Subject: AP1000 COL Response to Request for Additional Information (TR 29)

Westinghouse is submitting a revised response to the NRC request for additional information (RAI) on AP1000 Standard Combined License Technical Report (TR) 29, APP-GW-GLR-044, Nuclear Island Basemat and Foundation. This RAI response is submitted in support of the AP1000 Design Certification Amendment Application (Docket No. 52-006). The information included in the response is generic and is expected to apply to all COL applications referencing the AP1000 Design Certification and the AP1000 Design Certification Amendment Application.

RAI Response Number: RAI-TR29-SRSB-01
Revision: 1

Figure 3-1
Four Cold Legs in Operation, Two Pumps Coasting Down

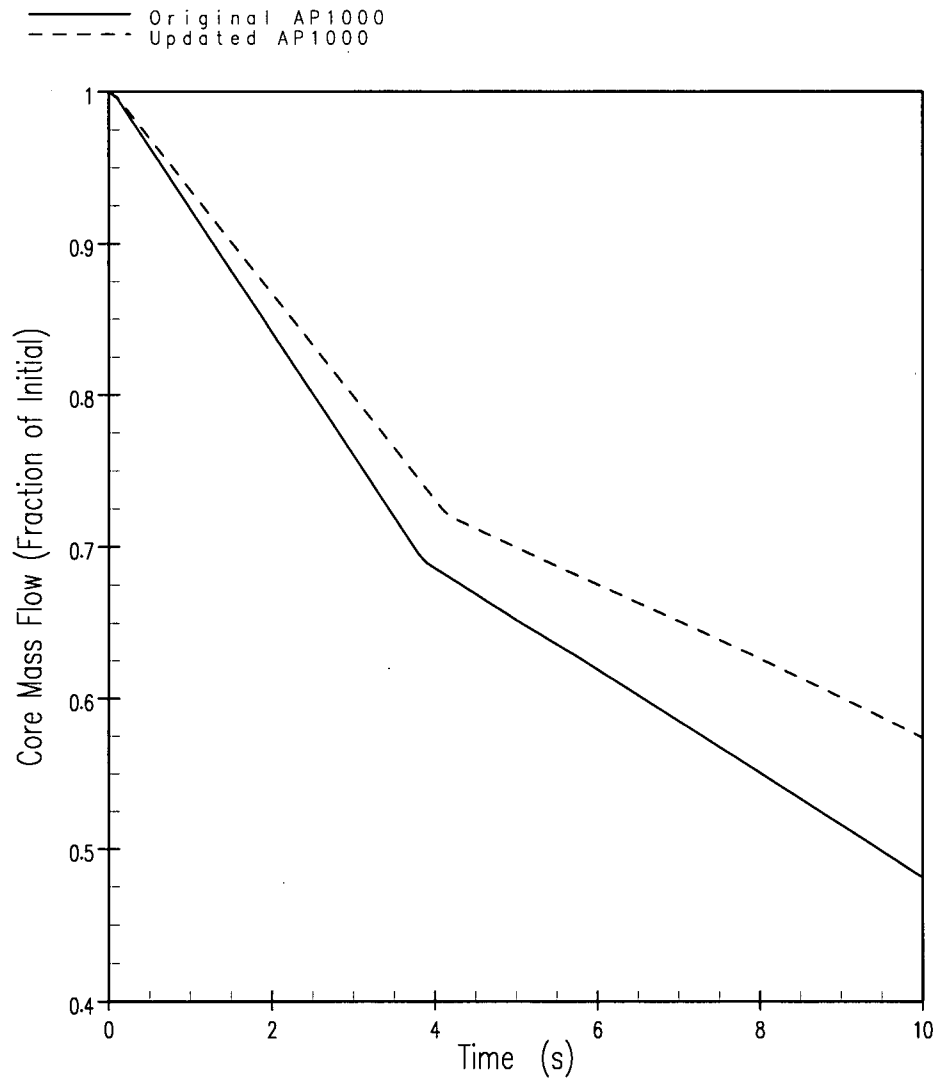
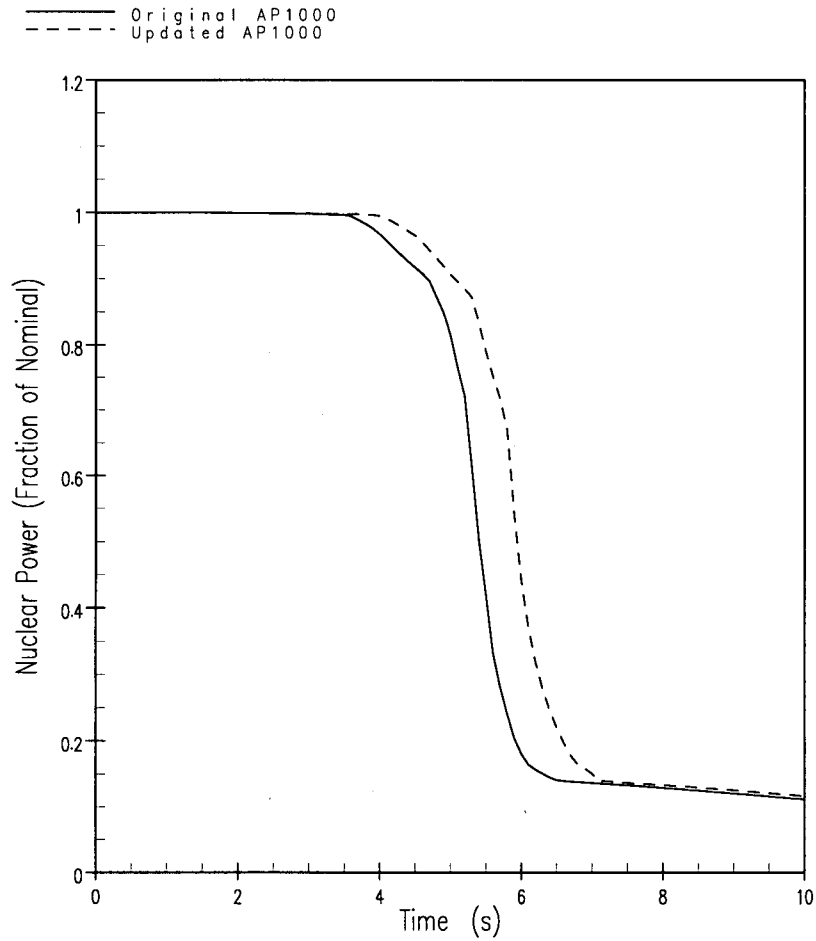
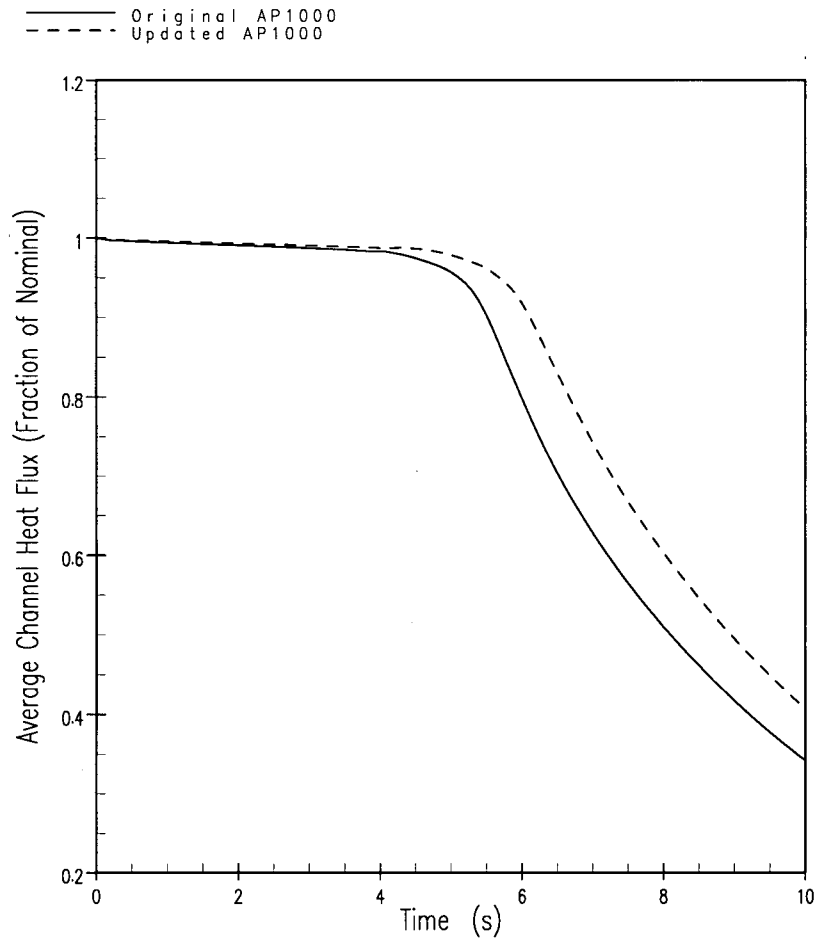
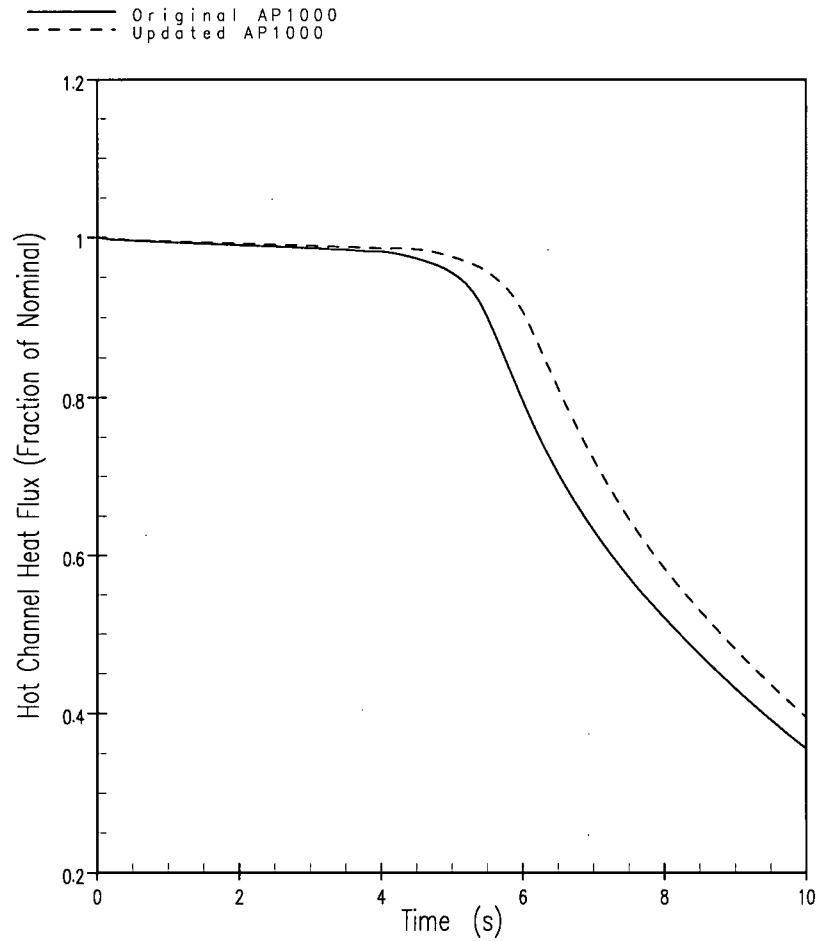
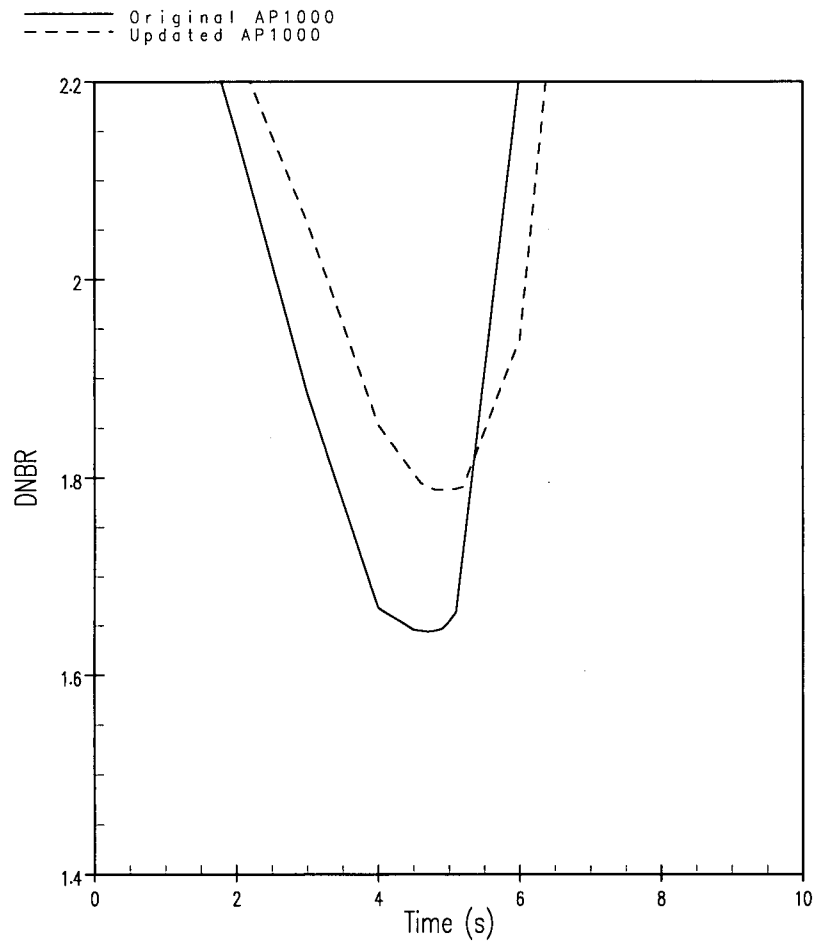
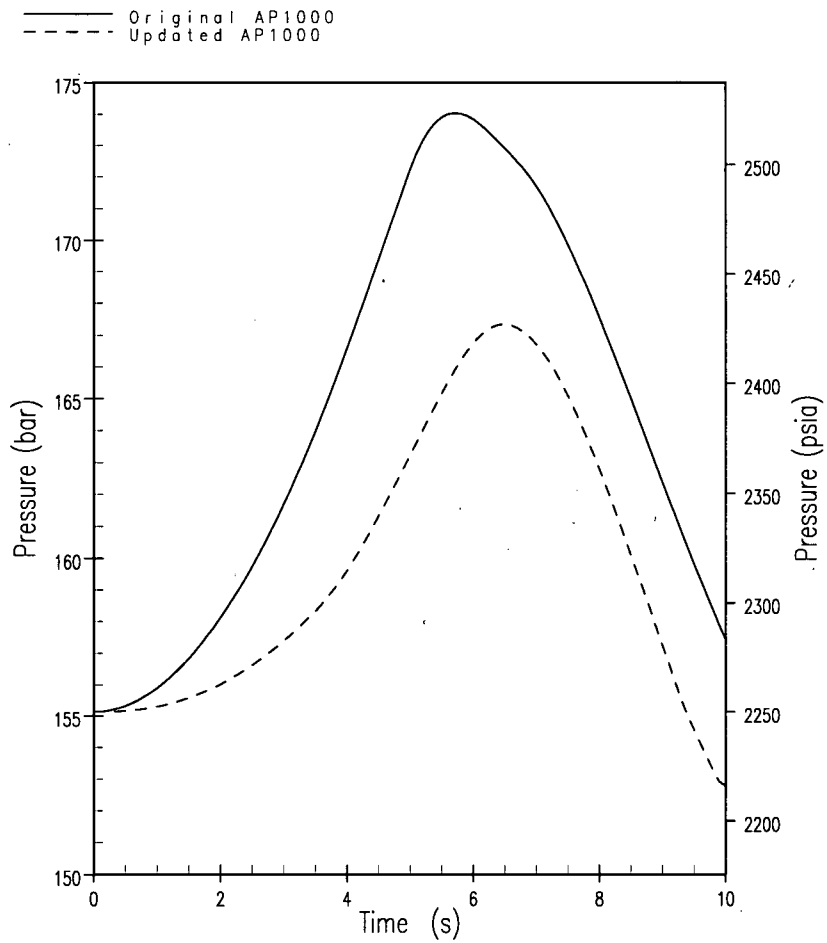
Please provide an evaluation of the impacts of these proposed changes on the analysis results of each of the transients and accidents in DCD Chapter 15. The evaluation should demonstrate either the analysis results of DCD Chapter 15, Revision 15, remain bounding and valid, or the effects of these changes are insignificantly small that the applicable acceptance criteria for these transients and accidents remain complied with.

With the updated AP1000 configuration, the results have improved. This is principally because there is a slight increase in the reactor coolant pump inertia from that used in the original AP1000 analyses (Reference 21) as a result of a more refined RCP design. The increased inertia results in a slightly slower reactor coolant pump coastdown (see Figure 3-1). With a slower reactor coolant pump coastdown, the time of reactor trip is delayed slightly. However, at the time of minimum DNBR, reactor coolant flow is slightly higher and minimum DNBR is higher. The DNBR safety analysis limit is 1.5. The original AP1000 configuration had a minimum DNBR of 1.64 for the partial loss of flow. The updated AP1000 configuration results in a minimum DNBR of 1.78.
